**BCTS Foghorn VIA Update
prepared by
RDI Resource Design Inc
March 18, 2016**

Visual Impact Assessment Summary Table

Sandbox Viewpoint VNS Simulations with Final WTPAs and NHZs as of 160318

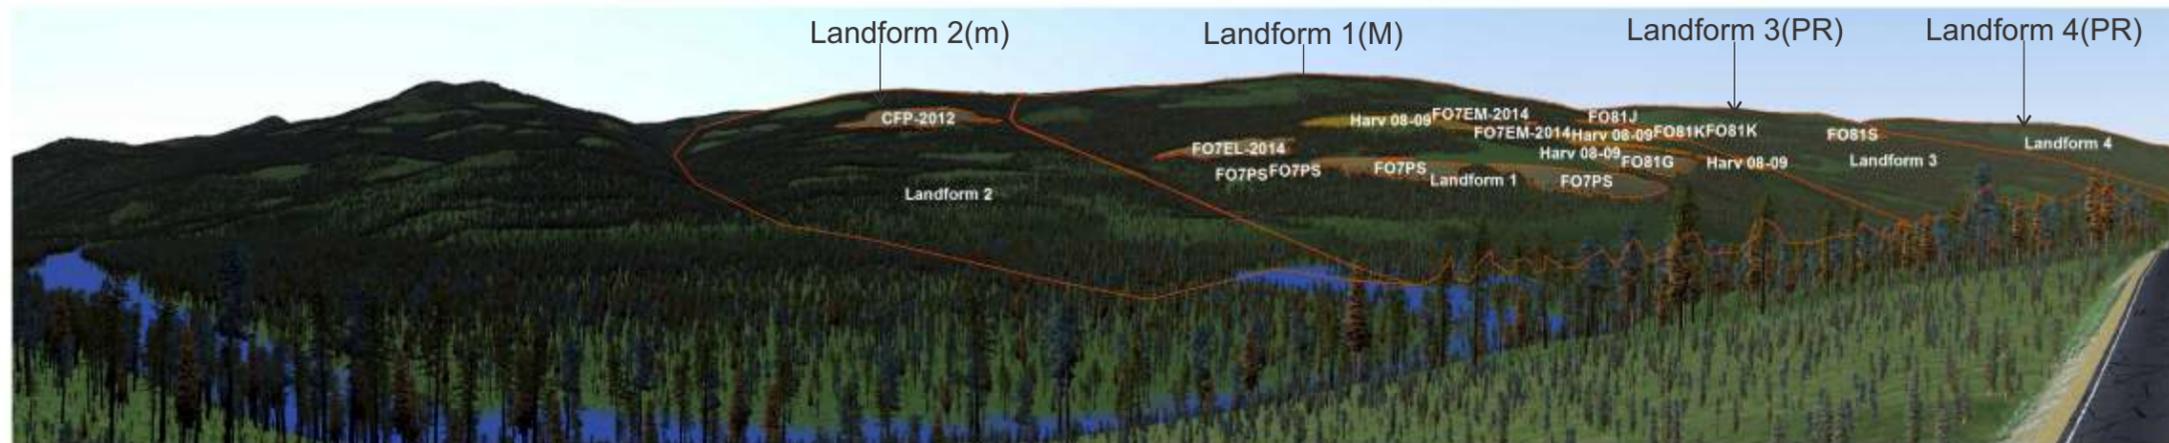
Fo7PS - reduced angularity, more leave patches
 Fo81G - reduced angularity, more leave patches
 Fo81S - reduced angularity, more leave patches
 Fo81J - reduced angularity, more leave patches
 FO81K - reduced angularity, leave patch
 Window in to view the distinctions between the two scenarios for Fo7PS, Fo81G, Fo81J, and Fo81S.

McCorvie Final - 160318 with KDC leave

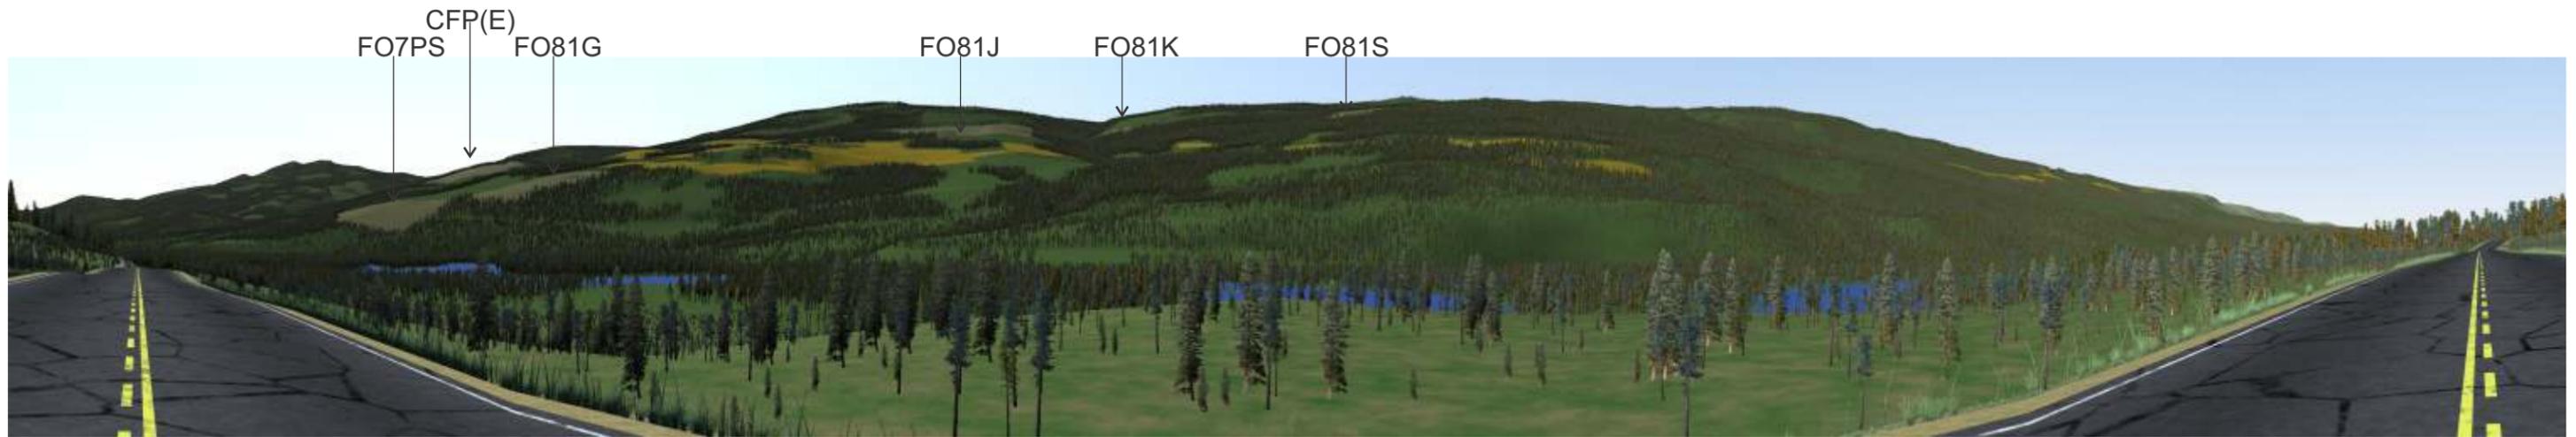
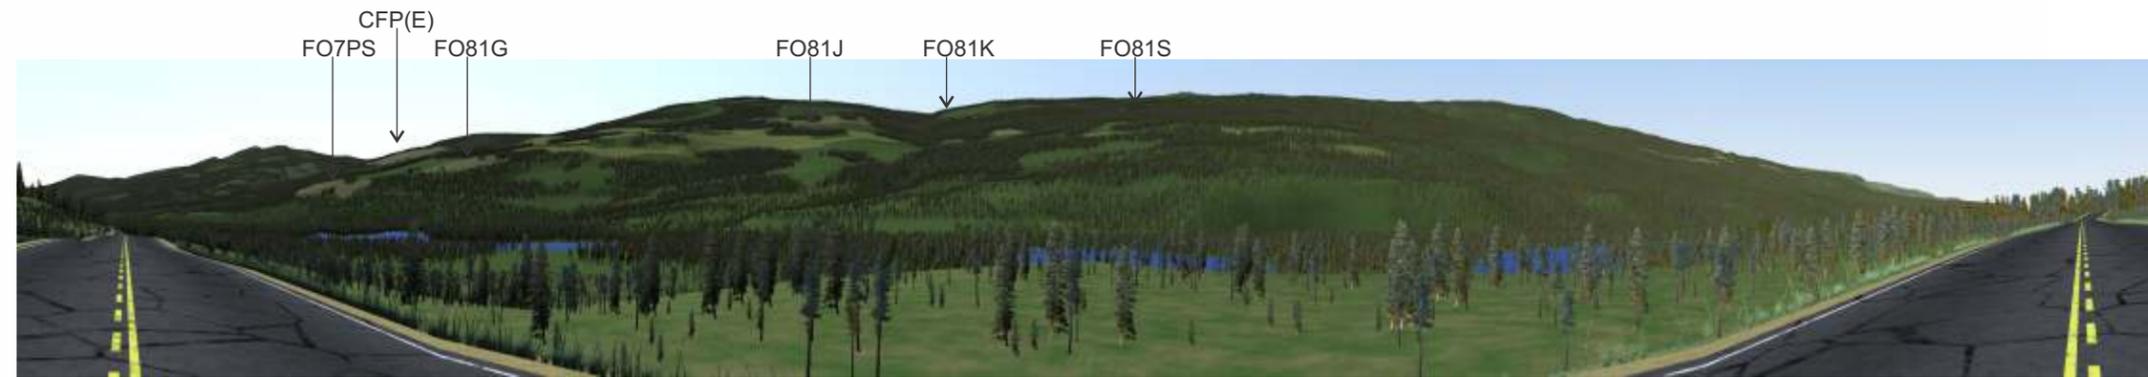
- Fo7PS - reduced angularity, more leave patches
- Fo81G - reduced angularity, more leave patches
- Fo81S - reduced angularity, more leave patches
- Fo81J - reduced angularity, more leave patches
- Fo81K - reduced angularity, leave patch

McCorvie with RDI Leave. Existing nonVEG in pale green.
Only Fo81K and Fo81S in L3. See also Sandbox.

Miller original. Existing nonVEG in orange.

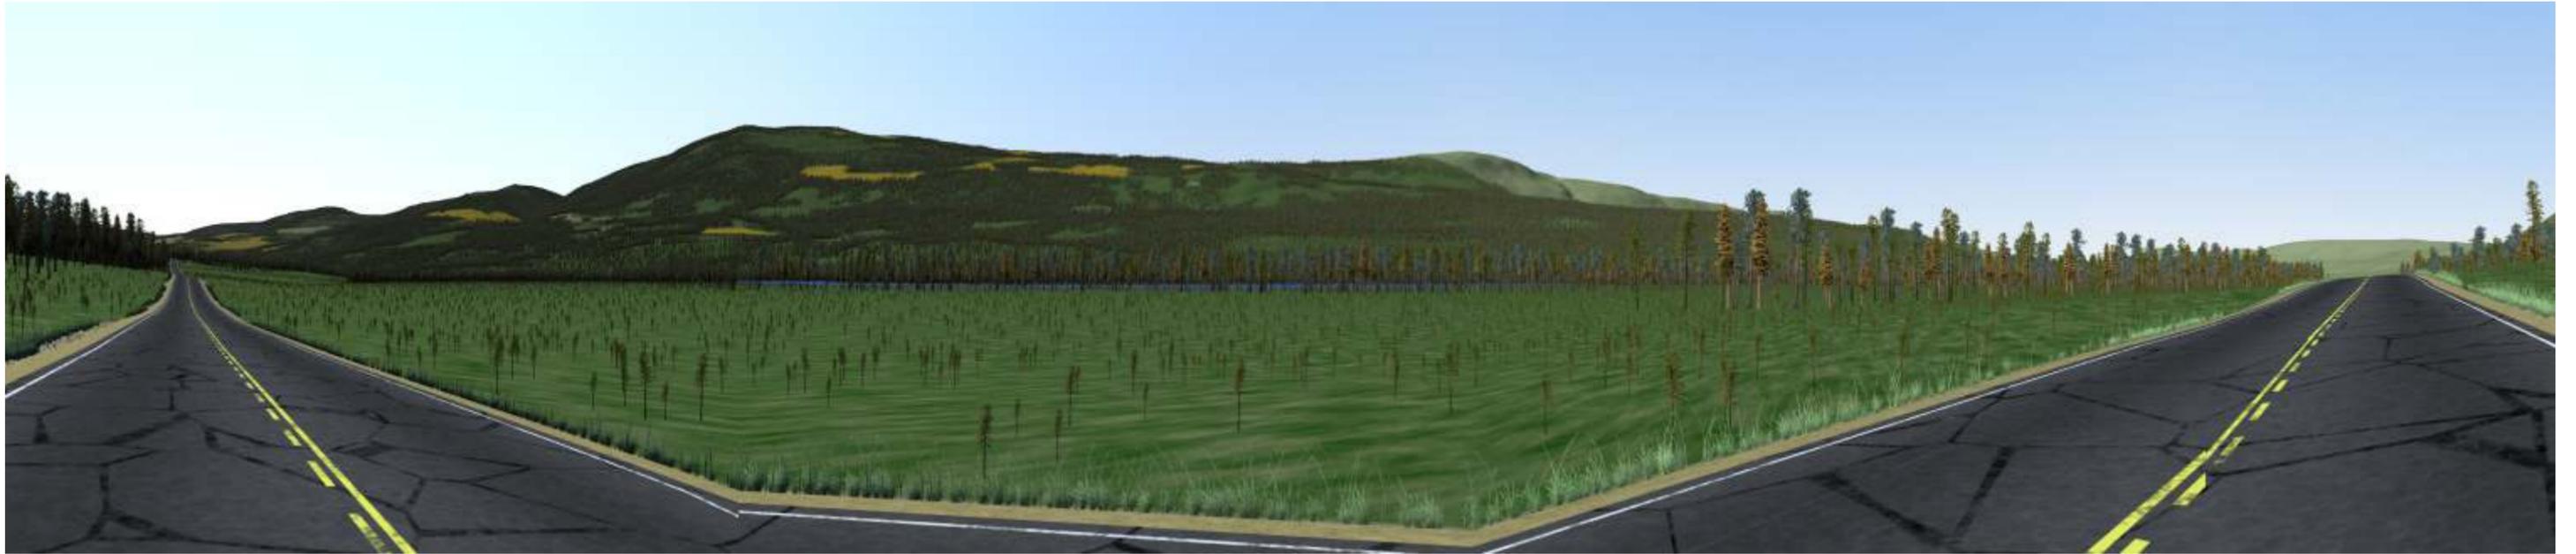
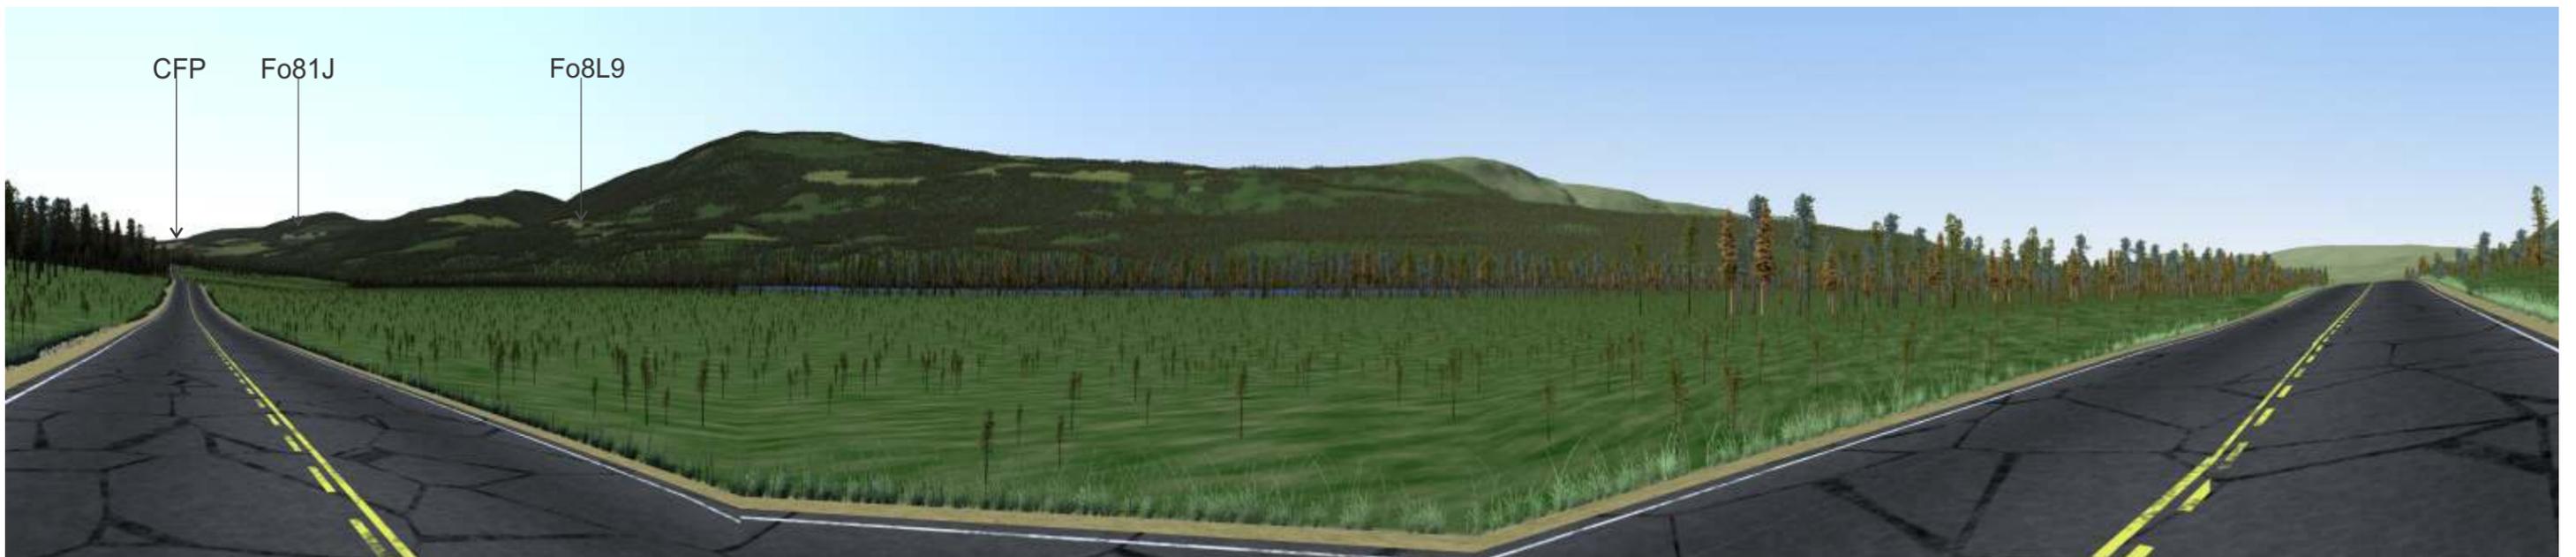
Fo81J- reduced angularity, more leave patches
 Window in to view the distinctions between the two scenarios for Fo81J.
 No Percent Alteration prepared for Landform 3 due small size of Fo8L9.

Raft original. Existing nonVEG in orange

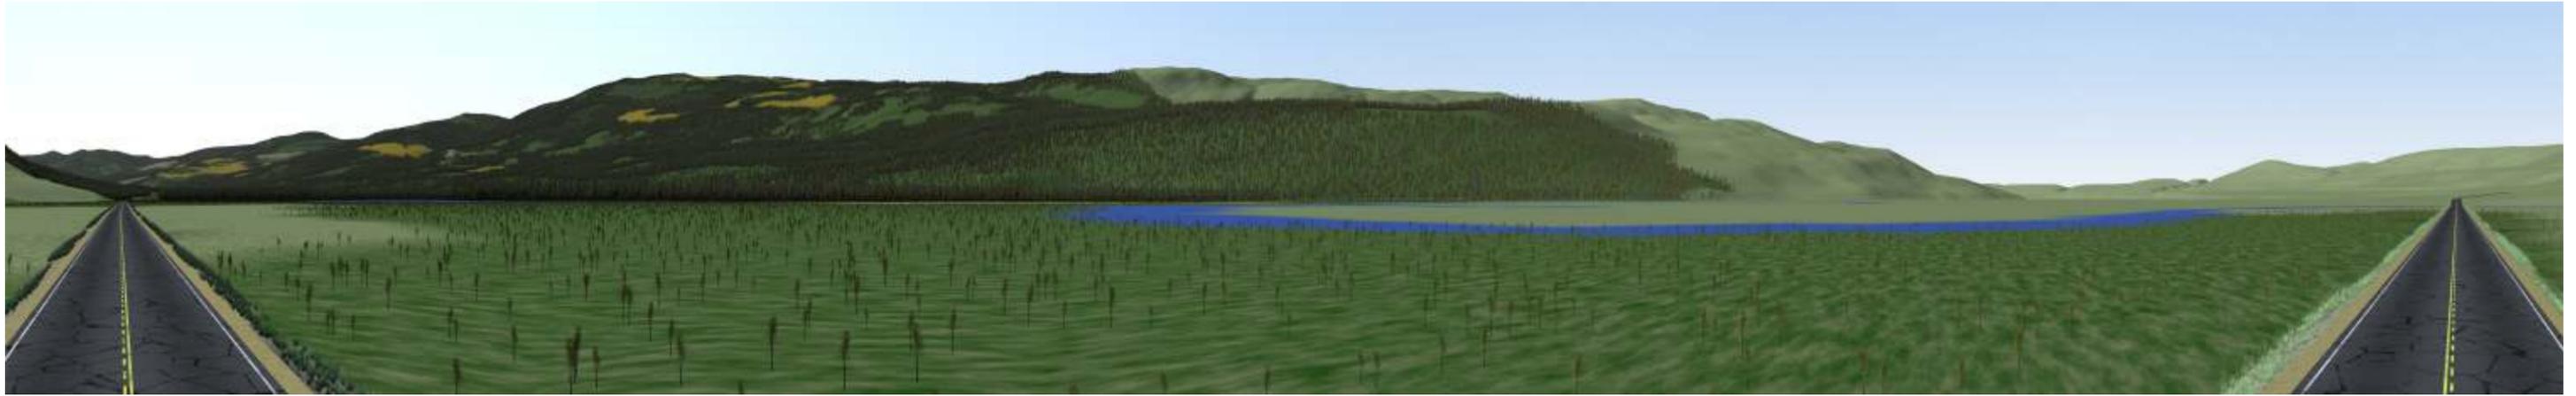
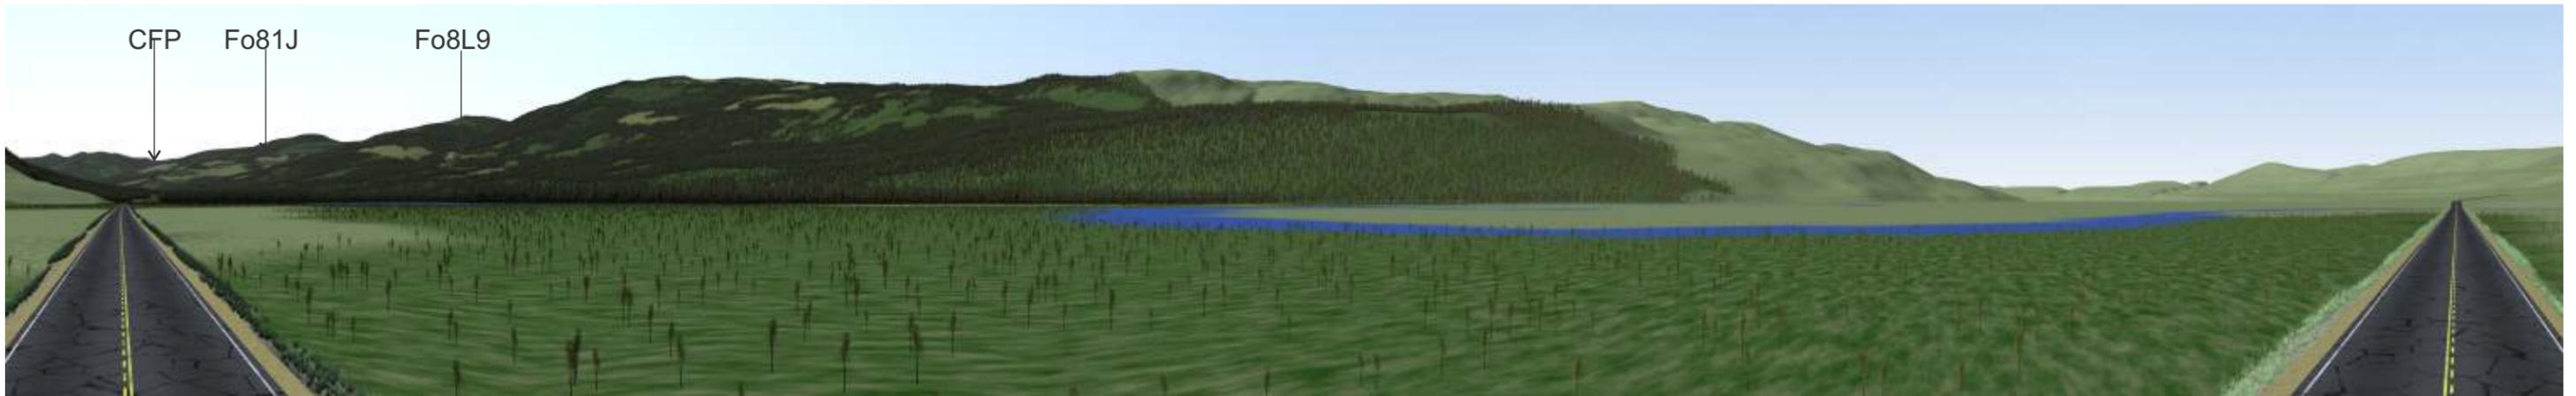
Fo81J- reduced angularity
